Project: MU/Patient Care Tower-1230- MRI Room

Subject: Addendum No. 1

ADDENDUM #1

TO CONTRACT DOCUMENTS FOR: Project #CP245321 – Patient Care Tower – T1230 MRI Room

1 Level 1 - FLOOR PLAN - SIEMENS EQUIPMENT
 1/4" = 1'-0"

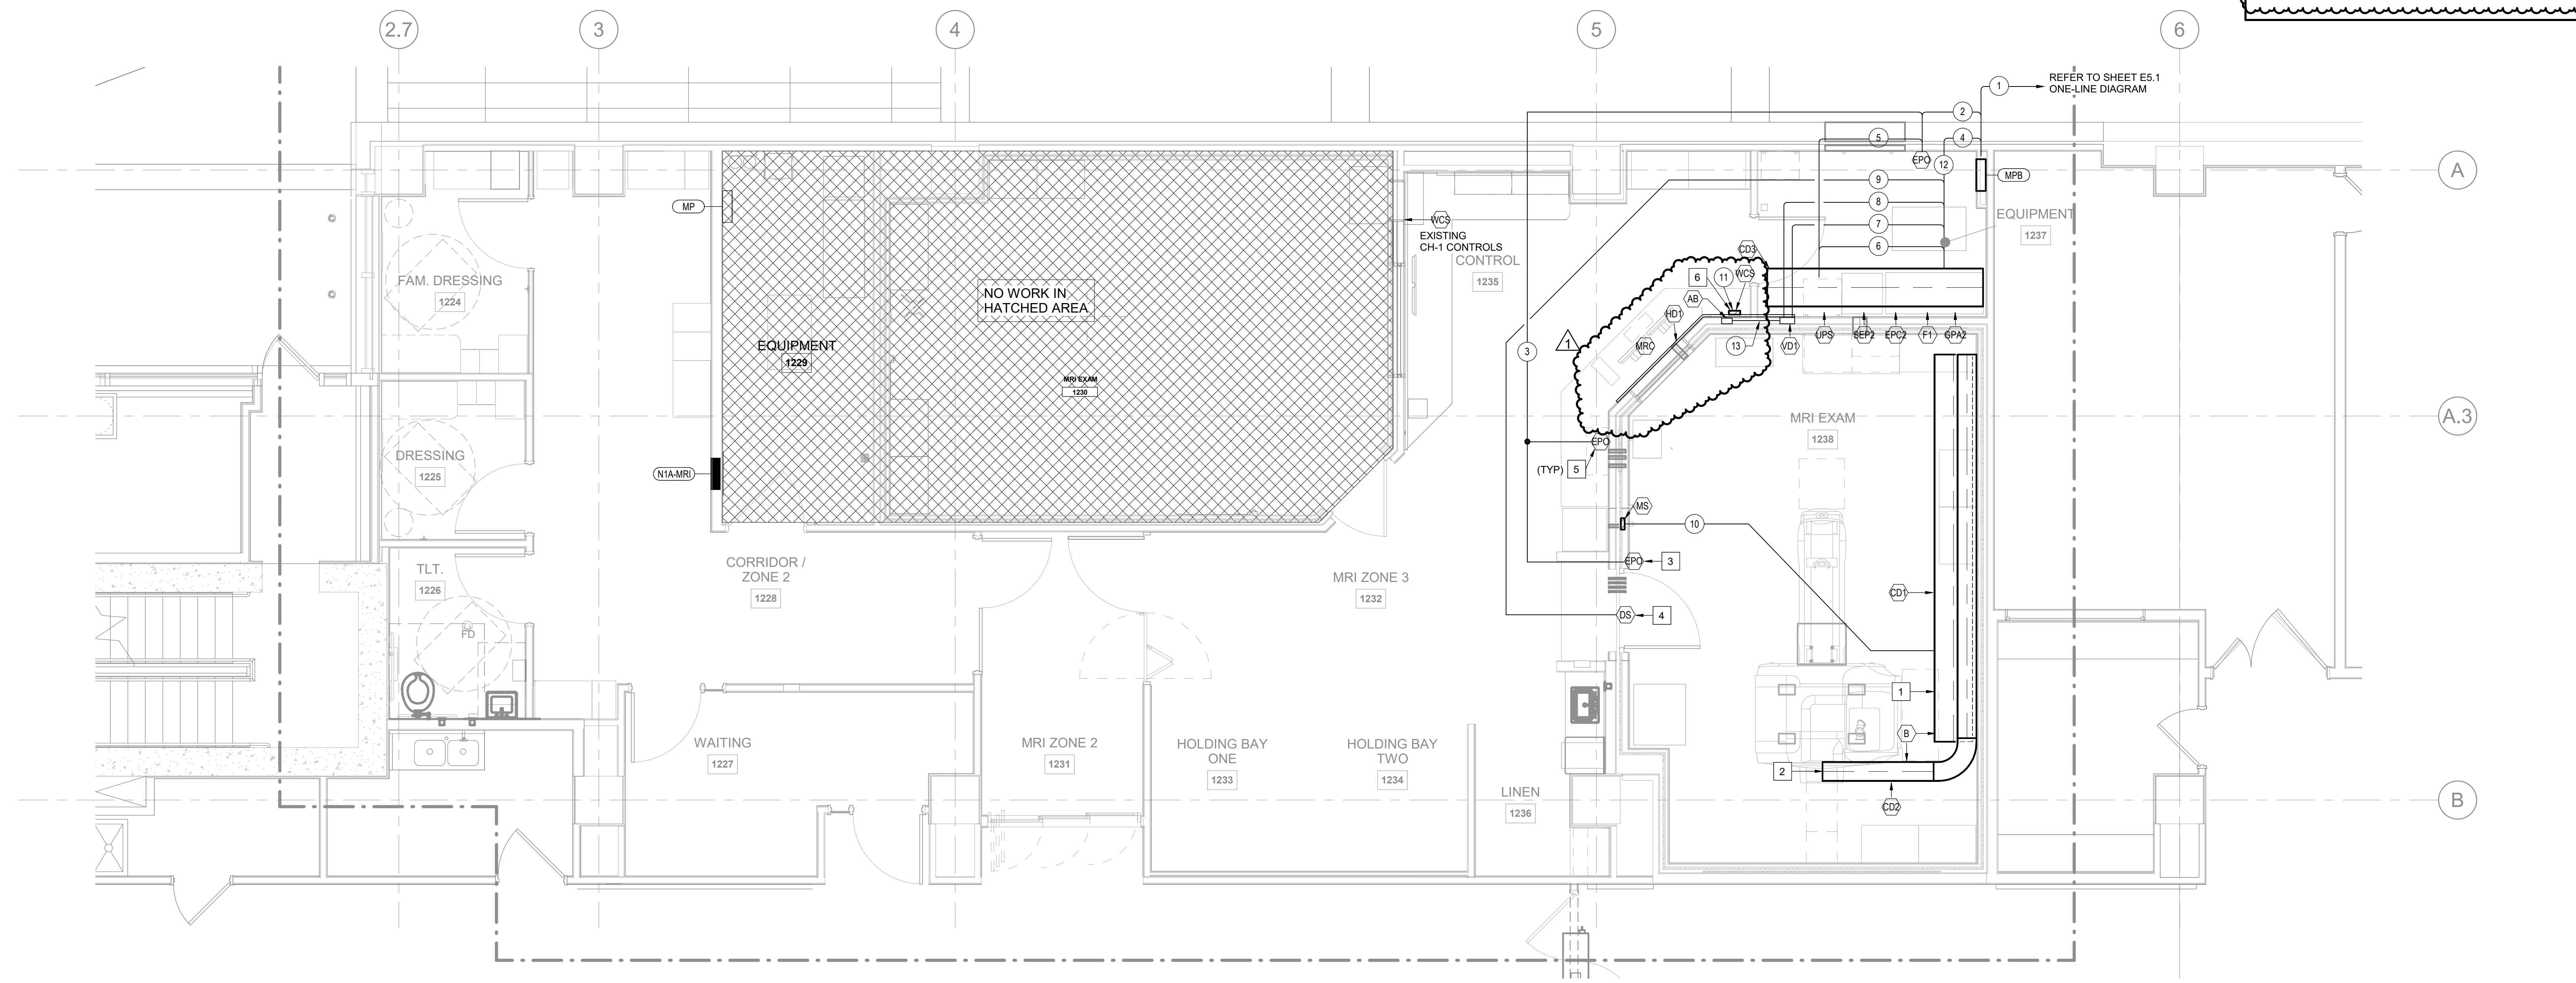
- a. **REVISED** descriptions and remarks in the electrical rough-in & legend schedule.
 - b. **REVISED** general notes A, B, C & F.
 - c. **REVISED** plan notes 1, 2 & 6.

- d. **REVISED** location of chiller control panel 'WCS'.
- 9) E5.1 – One-Line Diagram
 - a. **REVISED** one-line diagram to show additional related panels being worked on in this project.
